SEWAGE DISPOSAL SYSTEM

HOWARD COUNTY HEALTH DEPARTMENT

SUBDIVISION Woodpoint

MAKE-UP FOR AREA LOST TO PROPOSED POOL LOCATION (BUILDING PERMIT No. 53341)

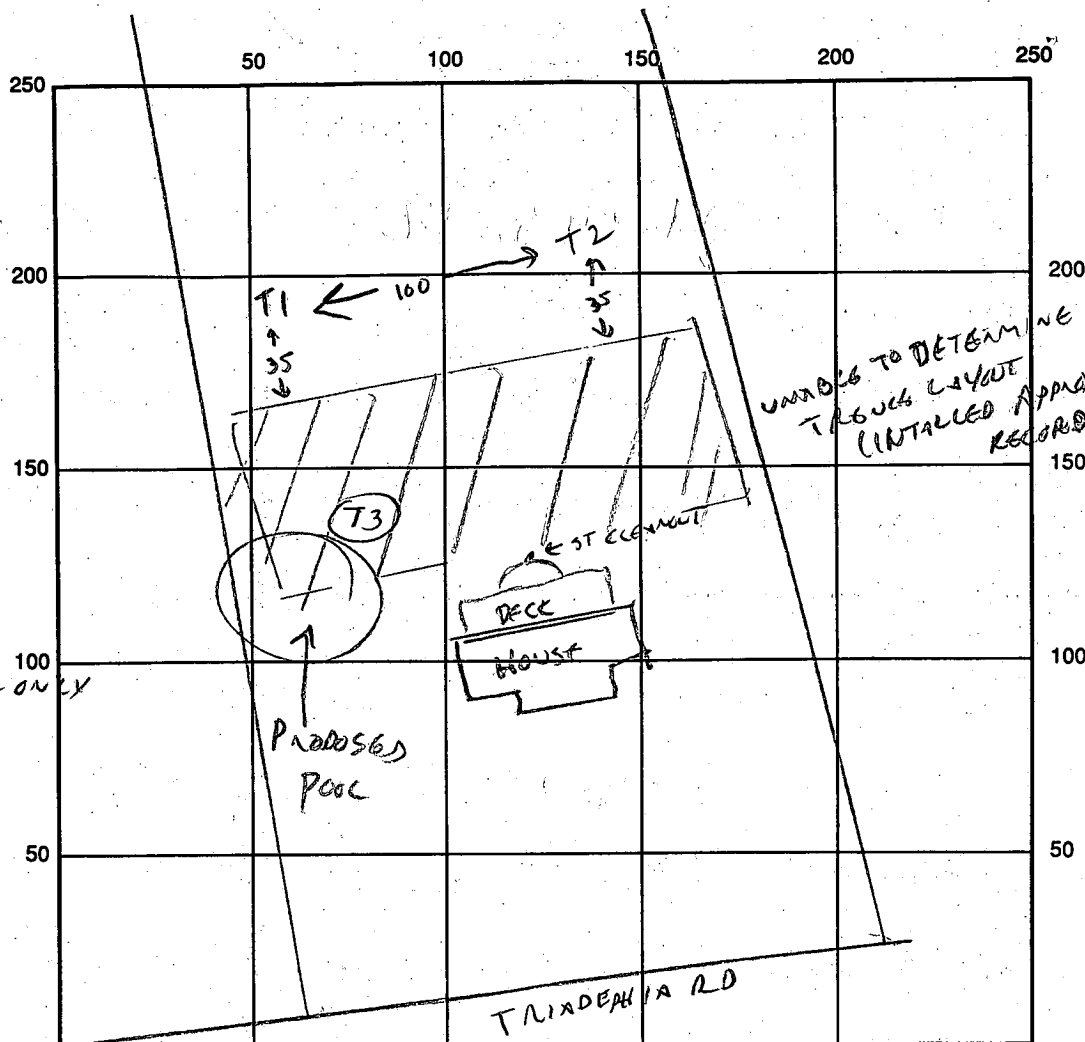
T-1
T-2
CLAY
3
MICA
LOAM
12
WATER
AT 12'
HOLE T-2 ONLY

T-3
VISUAL
TO 8'
TO CONFIRM
NO DISPOSAL
TRENCH IN
VICINITY
OF POOL.

REMARKS: 4/13/94 PROPOSED POOL - BP 53341 INTAUSES ON CORNER OF SEWAGE DISPOSAL EXHIBIT
MAY INTAUSE ON INSTALLED TRENCH LOCATION.

PERC TEST T-1 & T-2 VIS OK TO 11-12'

PERC TEST T-3 DUE TO 20' FROM EDGE OF PROPOSED POOL - NO DISPOSAL TRENCH IN AREA.

OK TO ALLOW ADJUSTMENT OF SEPTIC AREA RE: POOL INTAUSION
(PLAT NOT REQ'D)

DATE SYSTEM APPROVED OK TO PROCEED WITH POOL AS PROPOSED,
INSPECTOR _____

Revised
4/18/94
OK
Revision
4/21/94
CW

LAYOUT

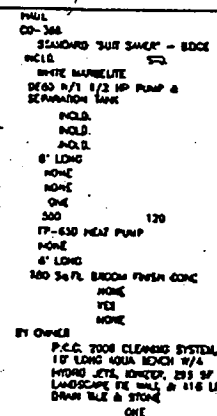
FURTHER FROM SEPTIC
TAN ORIGINAL PROPOSAL
(CW)

REVISION TO
4/21/94 BP 53341 OK
Gwilliam
